Staff Report Addendum

Subject: **8285 Piney River Avenue - Douglas County Libraries - Location and Extent - Supplemental Information**

Project File: **LE2025-025**

Re: ***LE2025-025 – Referral Response Memo***
Project #: 1296.0001.00

STERLING RANCH FILING 1, LOT X
DOUGLAS COUNTY LIBRARIES (L&E)
GRADING PLAN

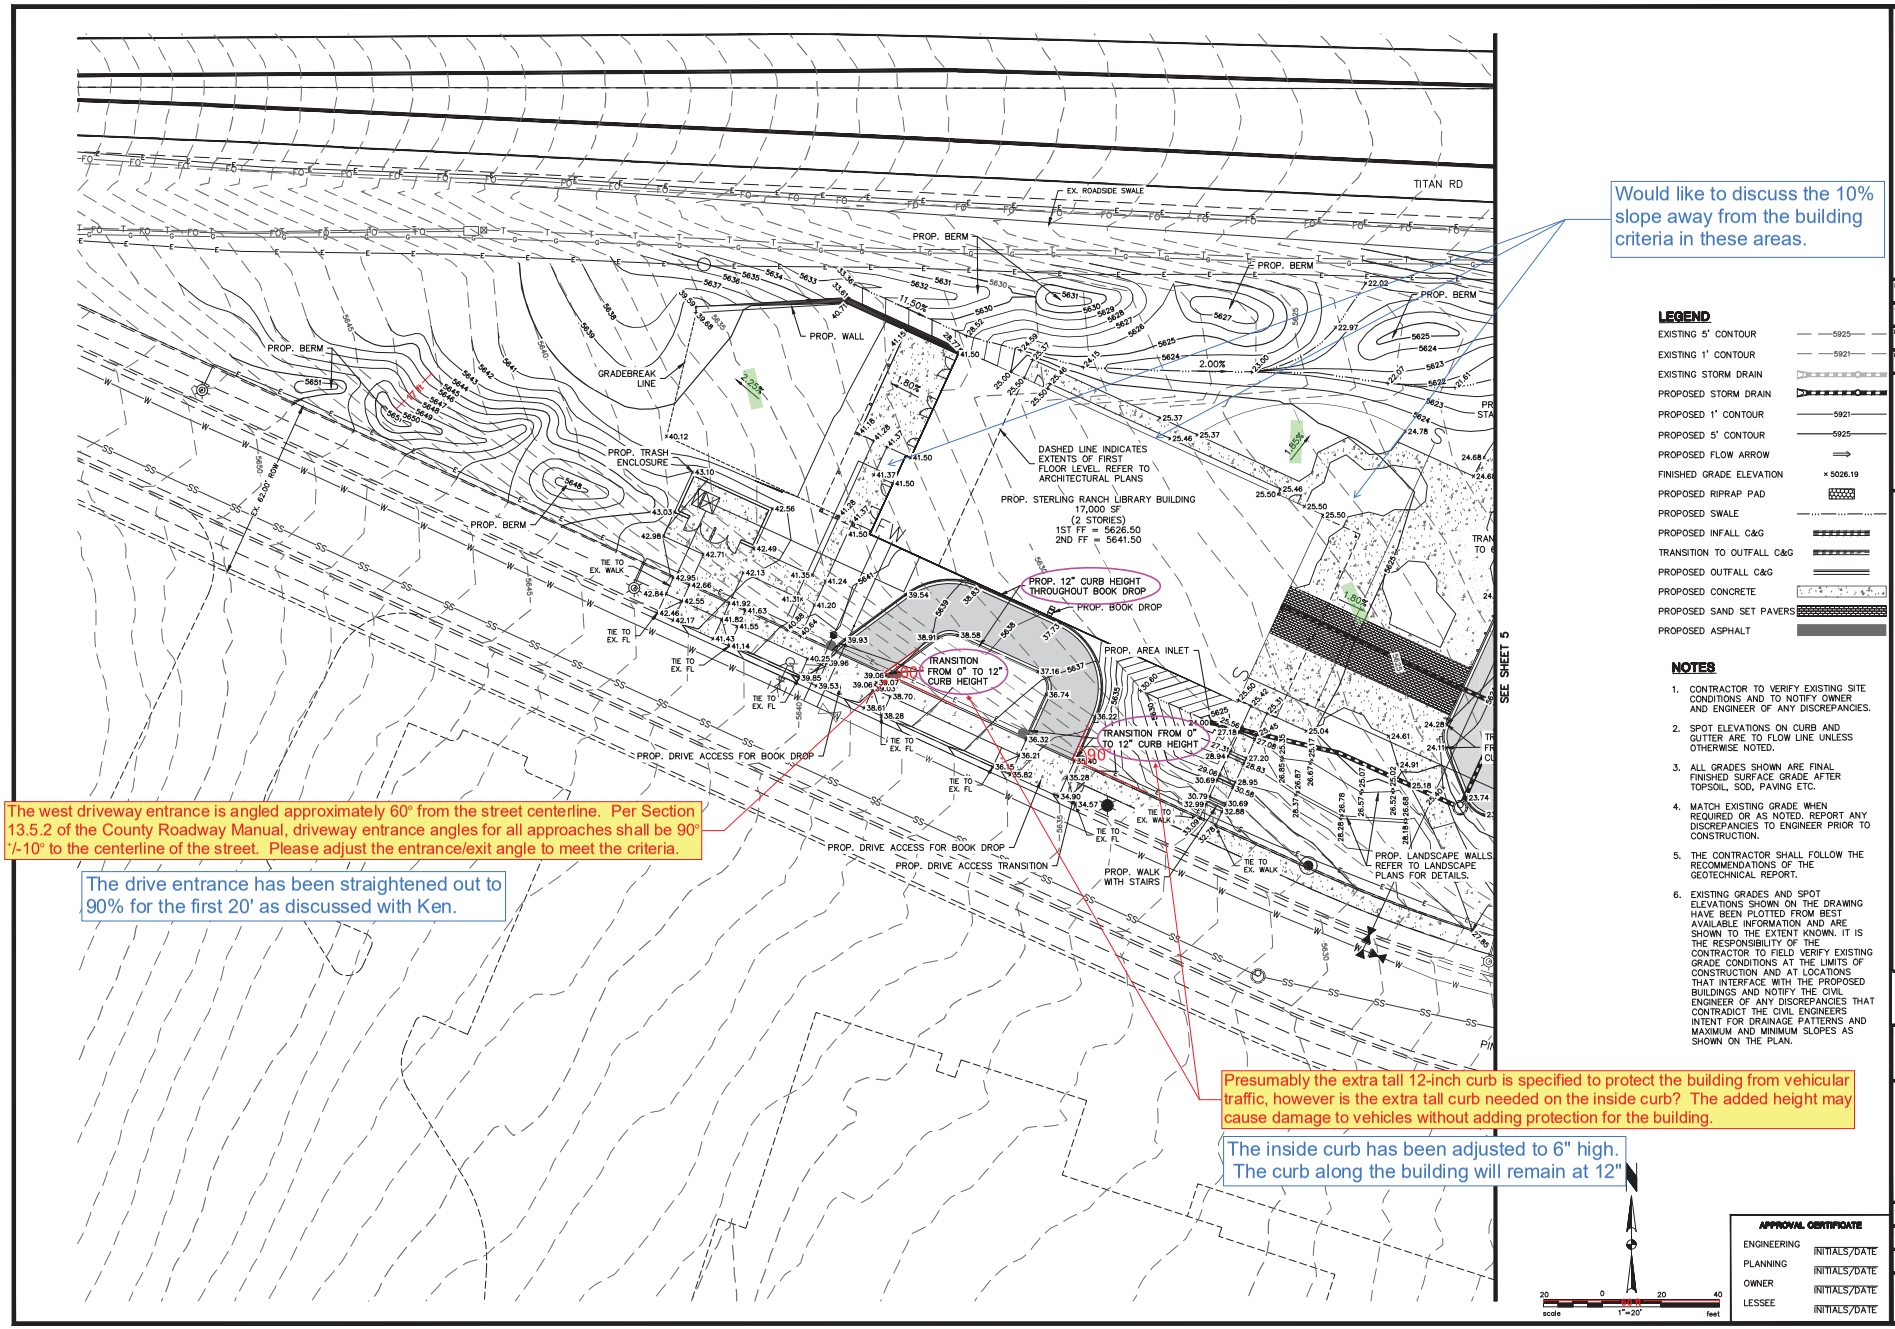
Would like to discuss the 10% slope away from the building criteria in these areas.

The west driveway entrance is angled approximately 60° from the street centerline. Per Section 13.5.2 of the County Roadway Manual, driveway entrance angles for all approaches shall be 90° +/-10° to the centerline of the street. Please adjust the entrance/exit angle to meet the criteria.

Presumably the extra tall 12-inch curb is specified to protect the building from vehicular traffic, however is the extra tall curb needed on the inside curb? The added height may cause damage to vehicles without adding protection for the building.

The drive entrance has been straightened out to 90% for the first 20' as discussed with Ken.

The inside curb has been adjusted to 6" high. The curb along the building will remain at 12"

LANDSCAPE SITE PLAN (WEST)

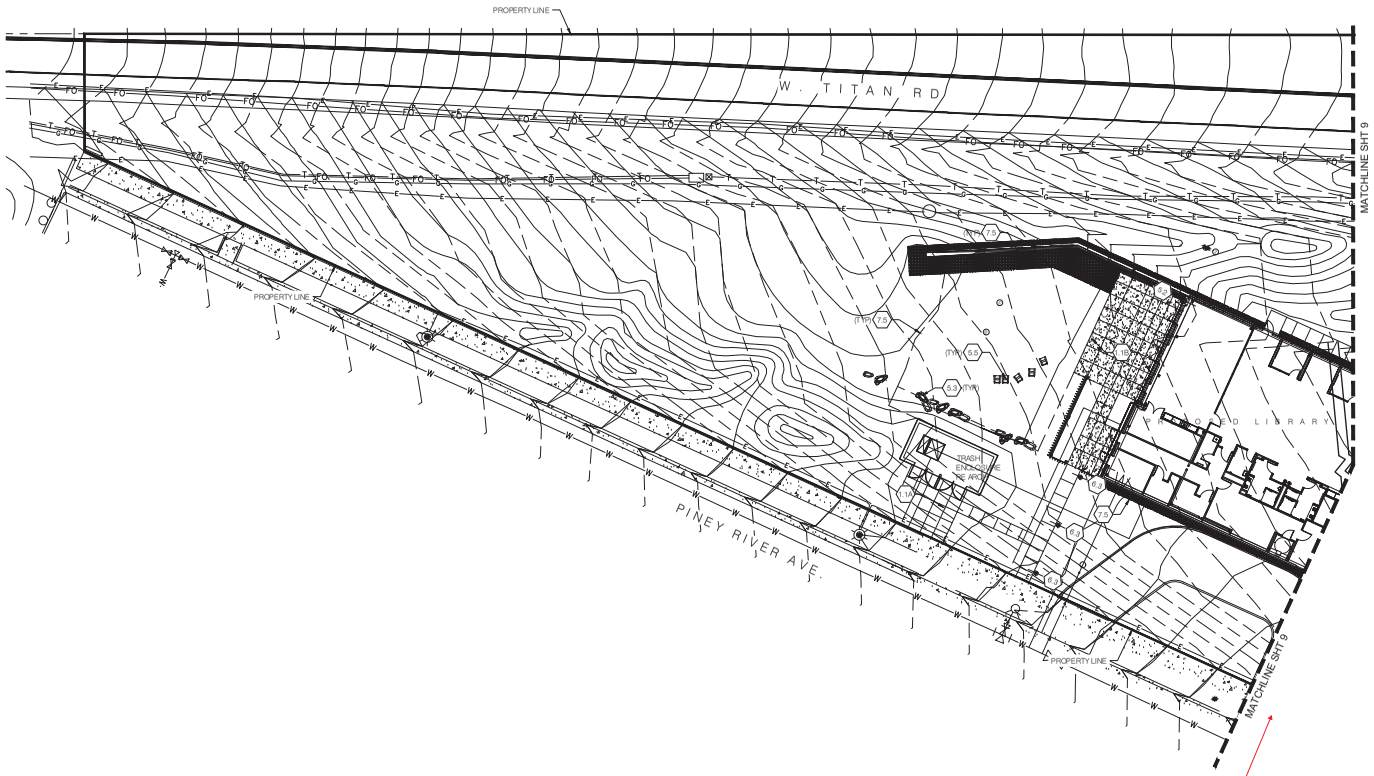
It appears a part of the site is missing between the matchlines shown on Sheets 8 and 9.

Check matchline locations and revise as needed.

Matchlines have been corrected.

Sheet numbe has been fixed.

PLANTING PLAN (WEST)

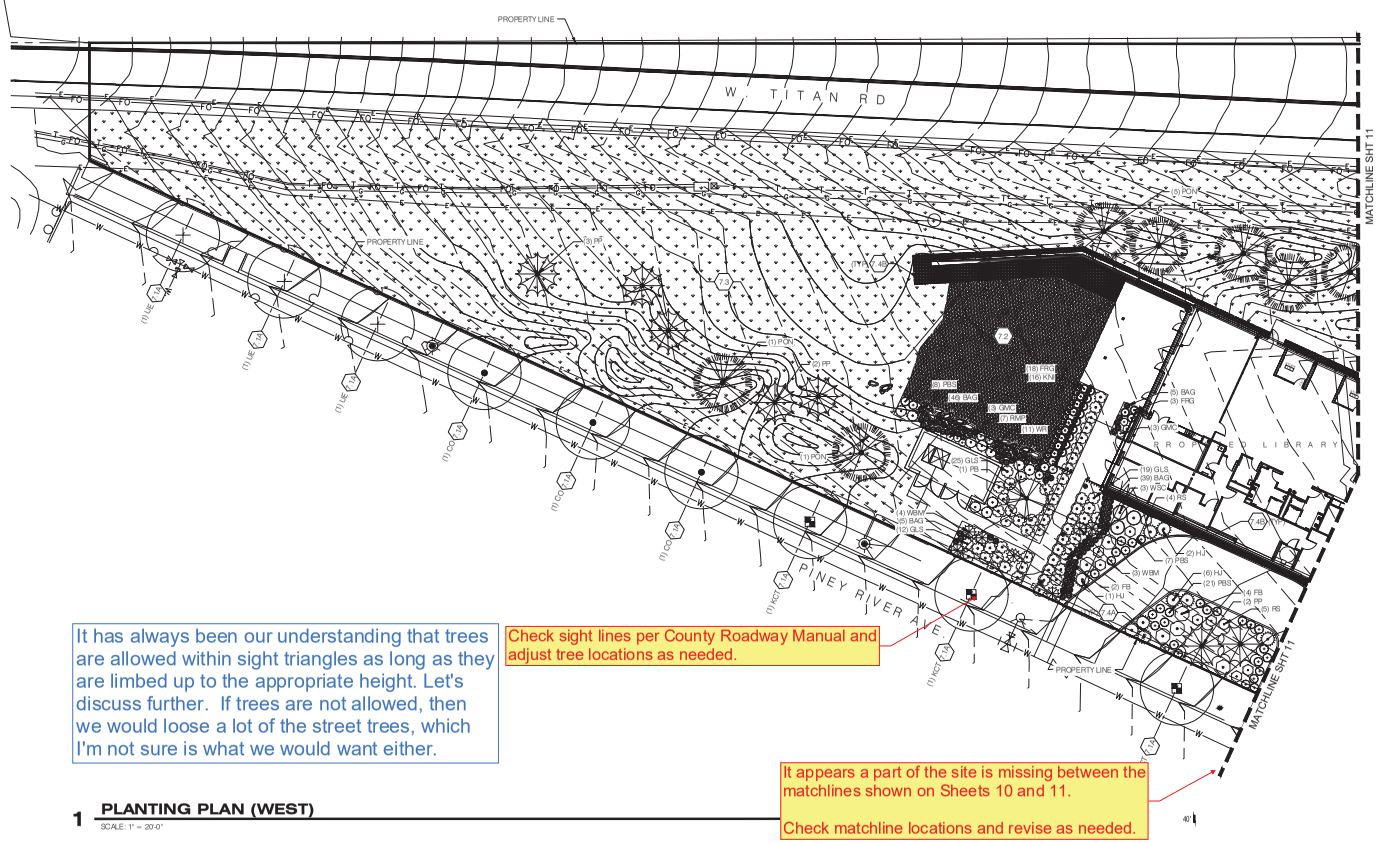
Check sight lines per County Roadway Manual and adjust tree locations as needed.

It appears a part of the site is missing between the matchlines shown on Sheets 10 and 11.

Check matchline locations and revise as needed.

It has always been our understanding that trees are allowed within sight triangles as long as they are limbed up to the appropriate height. Let's discuss further. If trees are not allowed, then we would loose a lot of the street trees, which I'm not sure is what we would want either.

Matchlines have been corrected.

1 **PLANTING PLAN (EAST)**
SCALE: 1" = 20'-0"

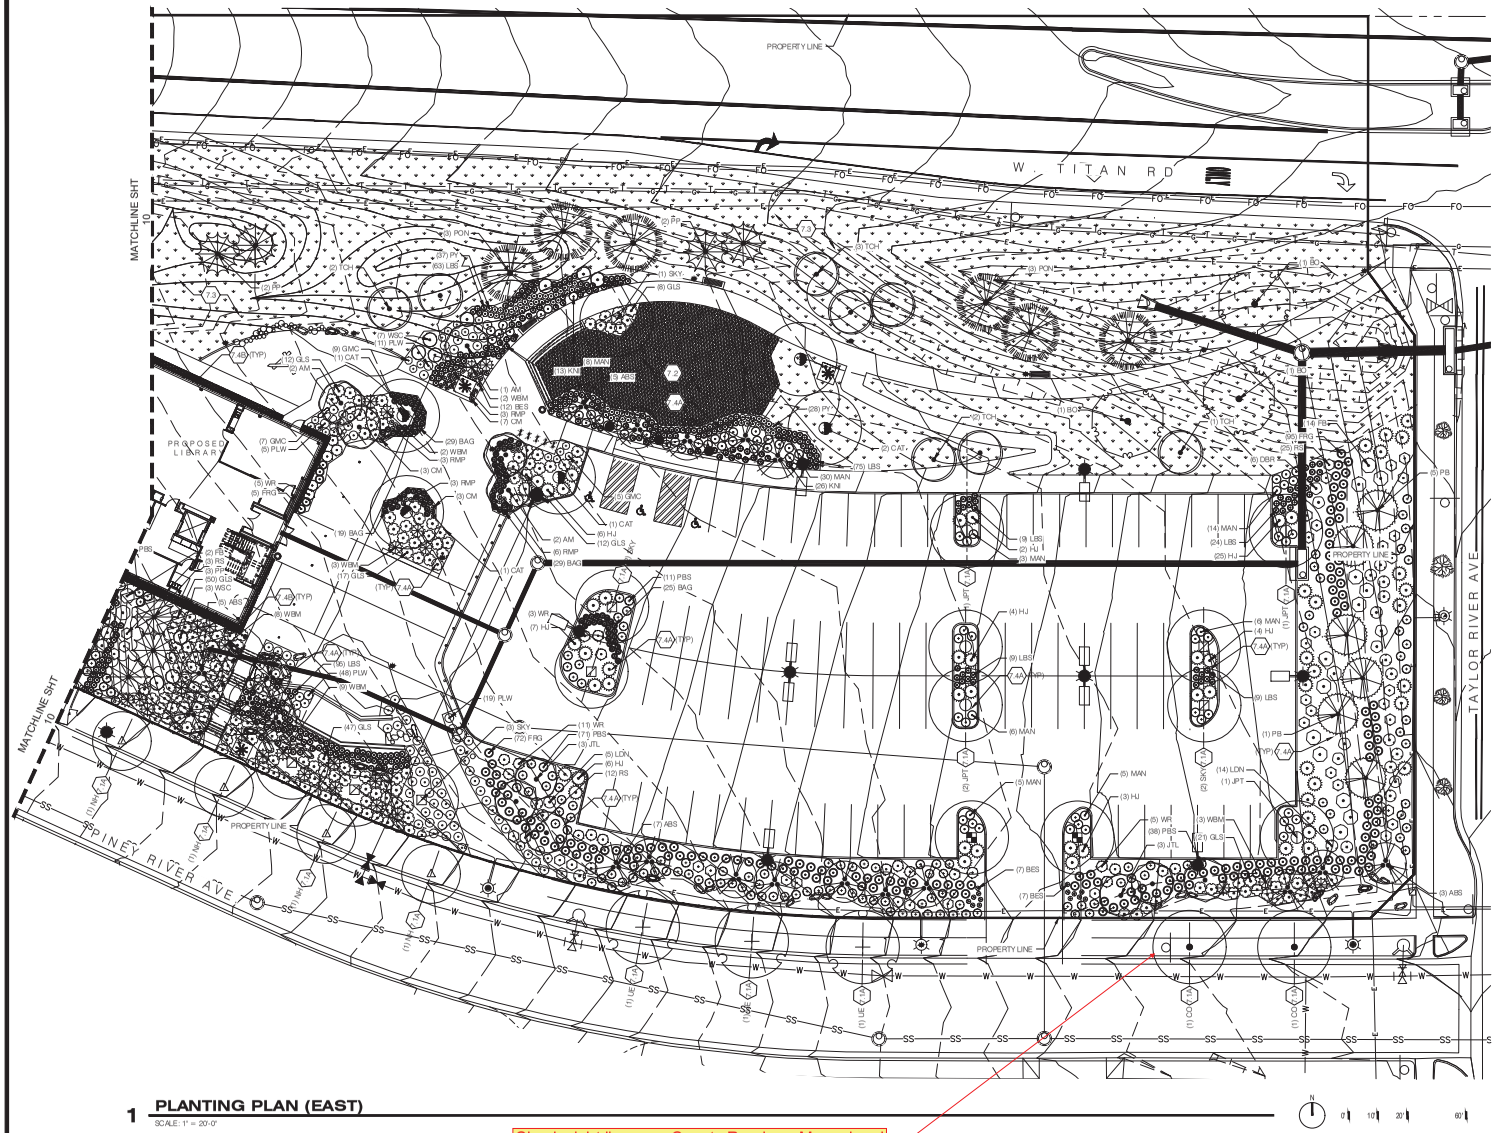
Check sight lines per County Roadway Manual and adjust tree locations as needed.

It has always been our understanding that trees are allowed within sight triangles as long as they are limbed up to the appropriate height. Let's discuss further. If trees are not allowed, then we would loose a lot of the street trees, which I'm not sure is what we would want either.
